## TRANSPORT IMPACT MEMORANDUM

<b>Client</b>	EDQ	<b>Date</b>	22 July 2024
<b>Project</b>	Northshore Hamilton – RAL Application	<b>Project No:</b>	P0042473
<b>Prepared By:</b>	Lee Flueckiger Alice Shi, RPEQ 22028	<b>Reviewed By</b>	Andy Johnston, RPEQ 24764

On 24<sup>th</sup> June 2024, the Minister for Economic Development Queensland issued a Further Issues Letter requesting additional clarification of items between the 95% Design by ADG Consulting Engineers, the Urbis 20% Design Report, and the Transport Masterplan Northshore Hamilton. The below table lists the transport related items and where the appropriate response is located within this Transport Memorandum.

Table 1-1 Schedule of IR Item Responses

Table 2-2 Section B – Brett Street

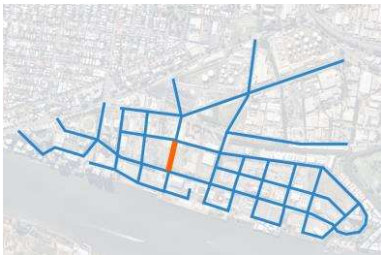
Item	Further Issues	Response / Page
	<ul style="list-style-type: none"> <li>Section A – Theodore St, central lanes narrower than masterplan (3.3m vs 3.5m)</li> </ul>	Page 7 – Section A
	<ul style="list-style-type: none"> <li>Section B - Brett Street - general traffic lane widths have been updated to be 3.5m and 3.3m rather than 3.5m and 3.5m</li> </ul>	Page 8 – Section B
	<ul style="list-style-type: none"> <li>Section C – Macarthur Avenue South 4 lane - general traffic lane widths have been updated to be 3.5m and 3.3m rather than 3.5m and 3.5m.</li> </ul>	Page 9 – Section C
	<ul style="list-style-type: none"> <li>Section D – Brett St, all four lanes narrower than masterplan (3.3m vs 3.5m).</li> </ul>	Page 8 – Section B
	<ul style="list-style-type: none"> <li>Section E – Cullen Avenue two additional lanes, (4 vs 2).</li> </ul>	Page 9 – Section E
	<ul style="list-style-type: none"> <li>Section F – Curtin Avenue – have been updated to 4.0m general traffic lanes.</li> </ul>	Page 10 – Section F

Section F	Transport Masterplan	April 2024 Design		
Road hierarchy	District Road	District Road	✓	
Traffic Lanes	2 Lanes @ 3.5m	3 lanes @ 3.5m NB inner lane @ 3.2m	○	
Parking Lanes	No Parking Lanes	No Parking Lanes	✓	
Comments	<p>Due to minor changes in trip distribution, the optimal intersection form reported by SIDRA analysis was for these channelised lanes to be constructed as full length lanes in lieu of short lanes. Analysis of the Brett Street / MacArthur Ave intersection is provided in Section 4.</p> <p>To ensure that 4-lanes would fit within the road reserve, the northbound inner lane has been designed with a reduced width of 3.2m. While this is lower than the typical lane width specified within the BCC Standard Road Sections, a turning lane can be a minimum 3.0m as per Austroad Guide to Road Design. This design solution has also been through a review with the BCC with no issues flagged. Furthermore, the SIDRA model reports that operations are acceptable.</p>

Table 2-7 Section F Curtin Avenue

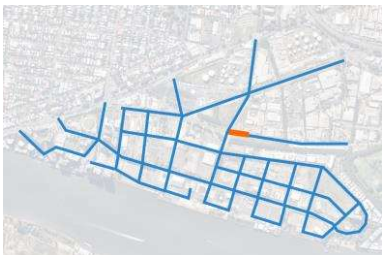
<ul style="list-style-type: none"> <li>Section L – Curtin Avenue (part 2) - No parking lanes provided despite 2 x 2.5m lanes required by masterplan – Removal/reduction of on street parking to be justified.</li> </ul>	Page 11 – Section i
	<ul style="list-style-type: none"> <li>Section N – Road 1 (part 1)- shared travel lane wider than masterplan (6m vs 5.5m)</li> </ul>	Page 10 – Section H
	<ul style="list-style-type: none"> <li>Section N – Road 1 (part 2) – Only 1 parking lanes provided despite 2 x 2.5m lanes</li> </ul>	Page 10 – Section H

Section L	Transport Masterplan	April 2024 Design		
Road hierarchy	Neighbourhood Road	Neighbourhood Road	✓	
Traffic Lanes	2 Lanes @ 2.75m	2 lanes @ 4.2m	○	
Parking Lanes	2 Parking lanes @ 2.5m	No Parking	✗	
Comments	The area accessed by this road will retain its industrial character in the development scheme. The proposed road design at the intersection has been reconfigured to better match and cater for the industrial nature of Curtin Ave. The current design of Curtin Avenue is industrial with an 8.0m carriageway by the intersection with Theodore Street to accommodate larger service vehicles. The Transport Masterplan recommendation of 2.75m lanes (5.5m two way carriageway) was suitable for a local residential road only, and not appropriate for ongoing industrial operation. Within the adopted section, the median is not proposed for the full length of Curtin Ave. On-street parking may still be retained outside of the immediate area on approach to the Theodore Street intersection and outside the scope of this application.

Table 2-8 Section G – Karakul Street, Road 5, Road 6

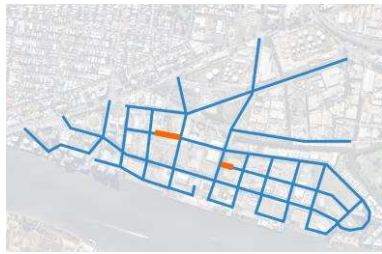
Item	Further Issues	Response / Page
	<p>required by masterplan – Removal/reduction of on street parking to be justified.</p>	
	<ul style="list-style-type: none"> <li>Section Q – Karakul St, Road 5, Road 6 - shared travel lane wider than masterplan (6m vs 5.5m).</li> </ul>	Page 13 – Section L
	<ul style="list-style-type: none"> <li>Section R – Riverfront lanes, Road 2,3,4,7,8,9 - shared travel lane wider than masterplan (6m vs 5.5m).</li> </ul>	Page 14 – Section N and Section M
	<ul style="list-style-type: none"> <li>Section C1 &amp; C2 – Riverfront Lanes (part 1) - shared travel lane wider than masterplan (6m vs 5.5m).</li> </ul>	Page 14 – Section N and Section M
	<ul style="list-style-type: none"> <li>Section C1 &amp; C2 – Riverfront Lanes (part 1) - Only 1 parking lanes provided despite 2 x 2.5m lanes required by masterplan – Removal/reduction of on street parking to be justified.</li> </ul>	Page 14 – Section N and Section M .

Section Q	Transport Masterplan	April 2024		
Road hierarchy	Local Road / Cycle Street	Local Road / Cycle Street	✓	
Traffic Lanes	Shared Travel Lane 5.5m	Shared Travel Lane 6.0m	○	
Parking Lanes	2 lanes @ 2.5m	2 lanes @ 2.5m	✓	
Comments	<p>Local road form adopted is consistent with DTMR Cycling Infrastructure Program, Technical Requirements 2017, and TRUM Part 8, for cycle street design. A wider shared travel lane is a safer outcome for the interaction of cyclists and vehicles. The 6.0m lane consists of two 1.3m textured surface areas for visual ‘narrowing’ of the street for a better a safe system approach.</p> <p>These textured areas are not ‘cycle lanes’, nor were they ever intended to be cycle lanes in the Transport Masterplan. This was always intended to be a cycle street and the design has been updated to ensure it matched TRUM.</p>

Table 2-10 Section i – Curtin Avenue West

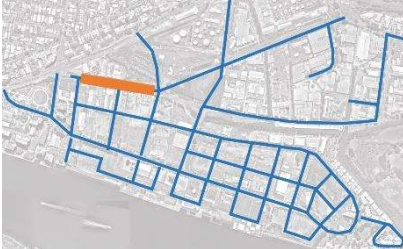
<ul style="list-style-type: none"> <li>Section H/G – MacArthur Avenue South, West of Theodore St, central lanes narrower than masterplan (3.3m vs 3.5m).</li> </ul>	Page 9 – Section C
	<ul style="list-style-type: none"> <li>Section G – Cullen Avenue (Central) – have been updated to 3.5m general traffic lane and 1.5m chevron, and 2 x 3.3m general traffic lanes.</li> </ul>	Page 9 – Section E
	<ul style="list-style-type: none"> <li>Section I – MacArthur Avenue South, West of Theodore St – lanes wider, (5.0m vs 3.5m).</li> </ul>	Page 9 – Section C and Table 2-5.
	<ul style="list-style-type: none"> <li>Section K – Cullen Avenue - two lanes narrower than masterplan (3.3m vs 3.5m).</li> </ul>	n/a – Cullen Avenue does not form part of this package.
	<ul style="list-style-type: none"> <li>Section L – Curtin Avenue (part 1) - two lanes wider than masterplan (4m vs 2.75m).</li> </ul>	Page 10 – Section F

Section O	Transport Masterplan	20% Design Proposal		
Road hierarchy	Neighbourhood Road	Neighbourhood Road	✓	
Traffic Lanes	Not Specified	2 lanes @ 3.0m	✓	
Parking Lanes	No parking	1 lane @ 2.5m	✓	
Comments	Lanes widths were not previously specified, and the proposed addition of on-street parking on one side does not significantly impact the design proposal. This design is consistent with the surrounding Local Roads.

Figure 3-2. Theodore Street / MacArthur Avenue North SIDRA Phasing Diagram

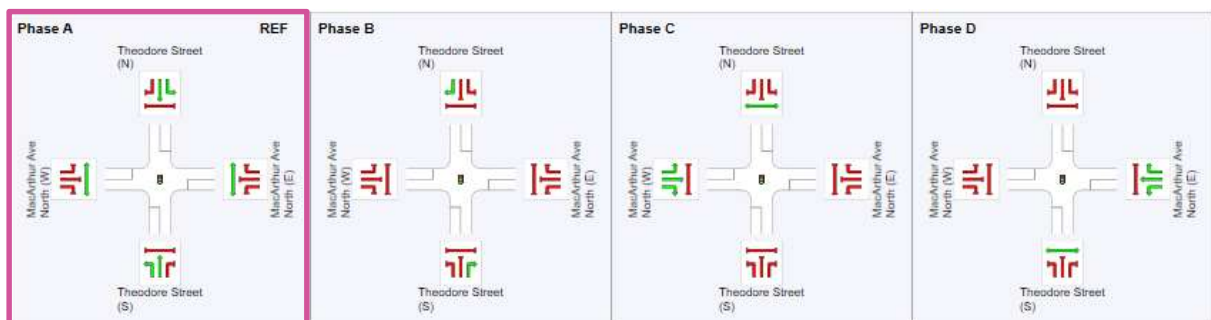
4.d.i	Council require full pedestrian protection from right turn movements for all signalised crossings.	There are no right turns coinciding with pedestrian crossing phases within the signal phasing for any site. For discussion on Phasing see page 3.1. Intersection configurations are enclosed in Appendix B.

Signal phasing for all signalised intersections is inclusive of pedestrian protection. This includes all areas where vehicles are turning left against a pedestrian crossing within the same phase, such as at Theodore Street / MacArthur Avenue North within Phase A of the below sequence.

To ensure that the pedestrian crossing is protected (red arrow for vehicles while pedestrians cross) either the Pedestrian Minimum Time or Clearance 1 Time is manually input. Manually setting the

Clearance 1 time to the length required to walk the crossing distance ensures that the last ped to start walking on the green signal (Min Walk Time) is provided sufficient time to make the entire crossing before a green arrow is shown. This is demonstrated in Figure 5.7.11 of the SIDRA User Guide and extracted in Figure 3- Pedestrian Timings3-3 below.

Figure 5-1. Driveway locations

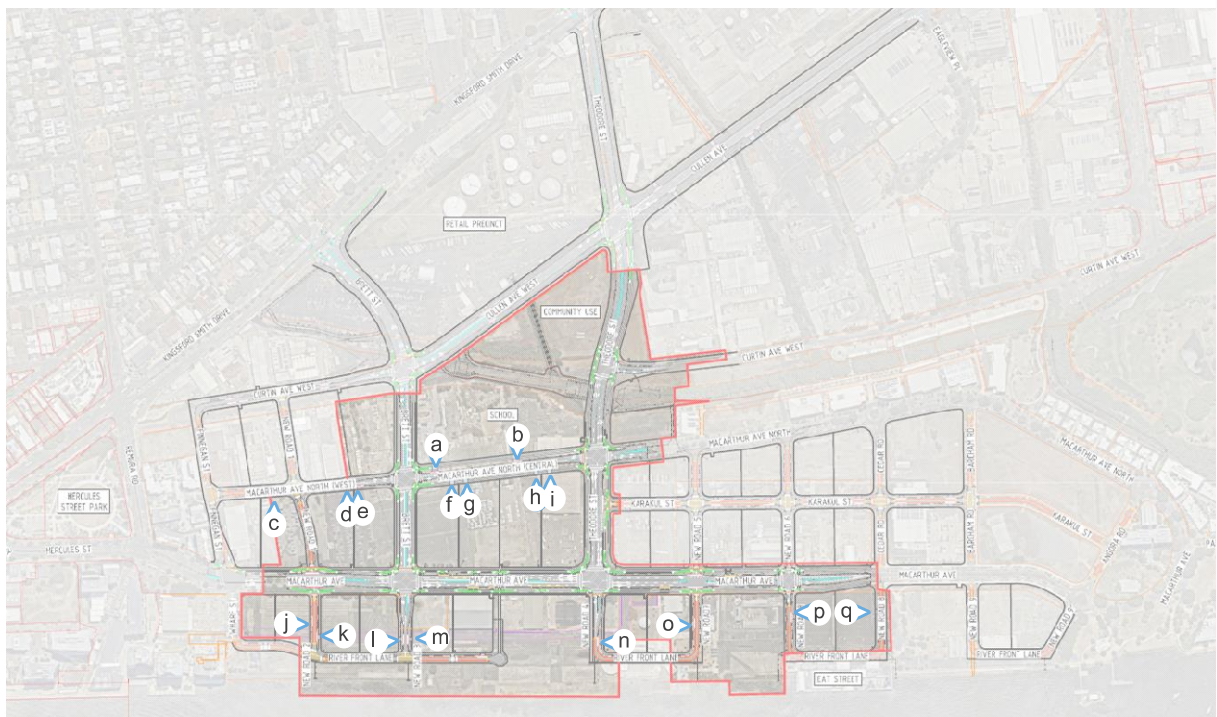
4.b	<p>Several proposed driveway access points are noted to be in close proximity to signalised intersections. Applicant to demonstrate that this will not cause safety or queuing length issues. Demonstrate the proposed haul road location (including vehicle crossovers) will not compromise the operational safety of MacArthur Ave. Where space is</p>	<p>Driveways within the assessment area are highlighted within Figure 5-1. Driveways presented within the development plans are indicative</p>

Driveways within the assessment area are highlighted within Figure 5-1 below. These driveways are identified as to maintain existing access to these properties in the most appropriate location. Further assessment would be required at the DA for each parcel to determine access for future development. Assessment of the indicative driveway locations to the standards outlined within the BCC TAPS are outlined within.

<b>Intersection Proximity</b>	<b>Sight Distance</b>	<b>Movements</b>	<b>Comments</b>
A – MacArthur North	20.0m from a Major intersection – Departure side	>100m straight approach, other approaches signal controlled	Left In – Left Out Median Controlled	Suitable location and form
B – MacArthur North	100m to a Major Intersection	>100m East >150m West	All Movements	Location is indicatively shown across the start of a short turn lane. This is not expected to compromise the efficiency or safety of the access.
C – MacArthur North (West)	30m to a minor intersection	>100m East on straight approach, other movements slowed on approach due to turning through the intersection	All Movements	Suitable location and form
D – MacArthur North (West)	60m to a major intersection 2.0m between driveways	>100m straight approach, other approaches signal controlled	All Movements	Driveway separation ensures 2.0m between the splays as indicated in BCC TAPS, at the property boundary driveway separation is greater than 9m. This is considered to be an acceptable outcome that is unlikely to compromise the safety or operation of the driveways.

S2. MacArthur Avenue North & Theodore Street	
Comments	
Northern Approach	N/A
Southern Approach	N/A
Eastern Approach	Addition of short left land at 40m long and a wider median as reflected within the road cross-sections
Western Approach	Addition of a short left turn lane at 95m long.

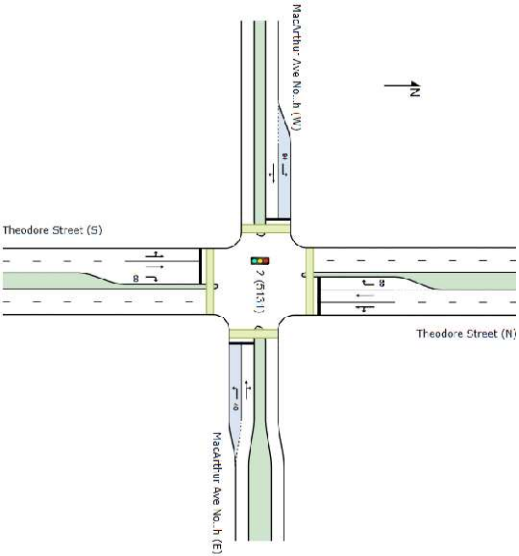
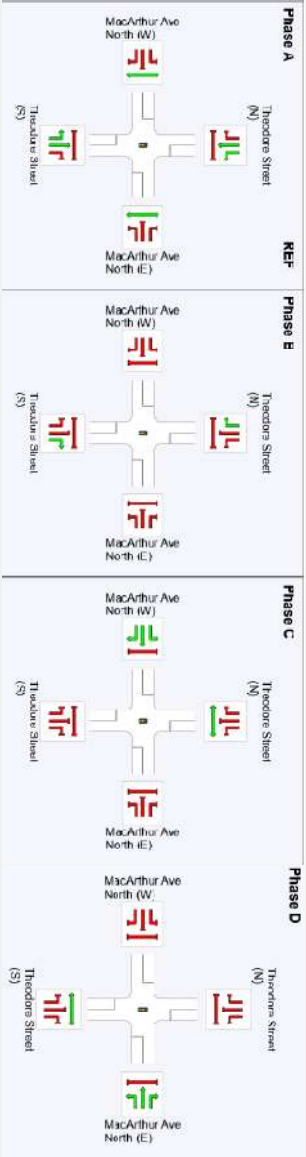
4.a.iii	<p>Some movement conflicts have been identified in the following intersections which can potentially impose safety risks:</p> <ul style="list-style-type: none"> <li>S6 – conflicts in phase A &amp; B,</li> <li>S7 – conflicts in phase A,</li> <li>S8 &amp; 9 – no phasing allocated to phase F,</li> <li>S10 – no phasing plan provided,</li> <li>S11 - conflicts in Phase A &amp; no phasing allocated to phase B,</li> <li>S12 &amp; 13 - no phasing plan provided.</li> </ul> <p>An updated SIDRA analysis will be required to incorporate the proposed speed reductions to identify any flow effects on</p>	S6 (Kingsford Smith Dr / Brett St), S8/9 (MacArthur Ave / Finnegan St / Wharf Cl), S12 (MacArthur Ave / Cedar Rd), and S13 (MacArthur Ave / Barcham Rd), are not within the assessment area and have been redacted from this report. Design of these intersections is ongoing. Nevertheless, S12 and S13 are priority controlled with no phasing applicable.

**S14. Theodore St / Curtin Avenue West**

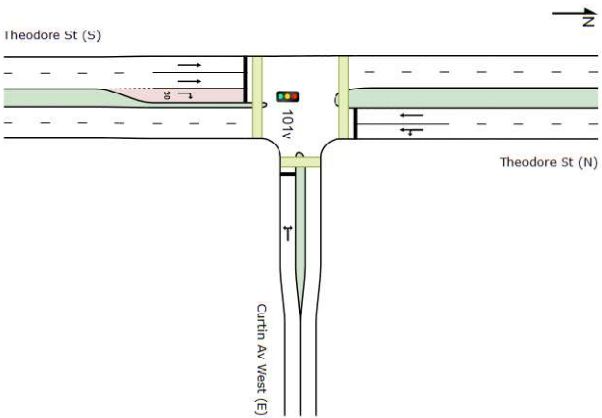
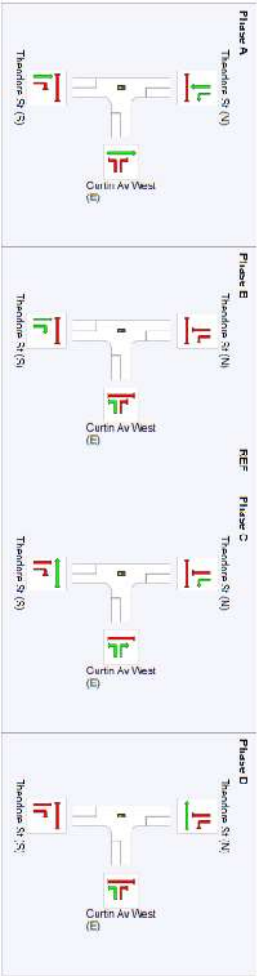
Item	Further Issues	Response / Page
4.a.v	<p>Master Plan Inconsistencies</p> <p>It is noted that inconsistency exists between the submitted Master Plan document, the 20% design report and the drawings dated 11/06/2024. The applicant is to justify the inconsistencies noted in the submitted Traffic Master Plan and clarify how these inconsistencies are dealt with in the 20% design report for the following noted items:</p> <ul style="list-style-type: none"> <li>▪ Typical Section B, Brett St – Design widths not consistent with District Rd figures, 3.2m turn lane proposed, however 3.5m required.</li> <li>▪ Typical Section E, Curtin Avenue – Road reserve listed as 20.3m but titled 18.5m (20m min). No bicycle lanes provided.</li> <li>▪ Typical Section F, Road 1 – Inconsistency with neighbourhood road figures. Lane width 3.4m less than required 3.5m and bicycle lane shown as 1.3m wide with 2.0m minimum required. It is not possible to have 2m cycle path and 3.5m wide car lane concurrently without encroaching on other cycle lane. Road reserve noted as 18.0m with 20m minimum.</li> <li>▪ Typical Section G, Karakul Street, Road 5, Road 6, and Macarthur Avenue north (West) – Appears to not be consistent with local road figures. Lane width 3.4m less than 3.5m required, bicycle lane shown as 1.3m wide with 2.0m minimum required. Not possible to have 2m cycle path and 3.5m wide car lane concurrently without encroaching on other cycle lane.</li> <li>▪ An additional signalised intersection on Macarthur Avenue has been included in the Traffic Master Plan that was not identified in the Development Scheme. Provide justification the change from the Development Scheme.</li> </ul>	<p>Within the section reviews of Item 4.a.i and Section 2 of this report, the design comparison has been updated to reflect the Transport Masterplan and the cross-sections within this application.</p> <p>The level of differentiation is minimal and where minor discrepancies occur, justification is provided in each comment section.</p> <p>The development scheme does not appear to show Finnegan St / Macarthur Avenue as a signalised intersection. However, the Transport Masterplan 2021 does show, model, and assess this intersection as a signalised 4-way intersection.</p>

Comments	This site has been subject to a design and safety review, see Appendix C. The outcome of this safety assessment determined that the intersection should be converted to a Signal Control.
Northern Approach	Signal Control
Southern Approach	Signal Control
Eastern Approach	Signal Control
Western Approach	N/A
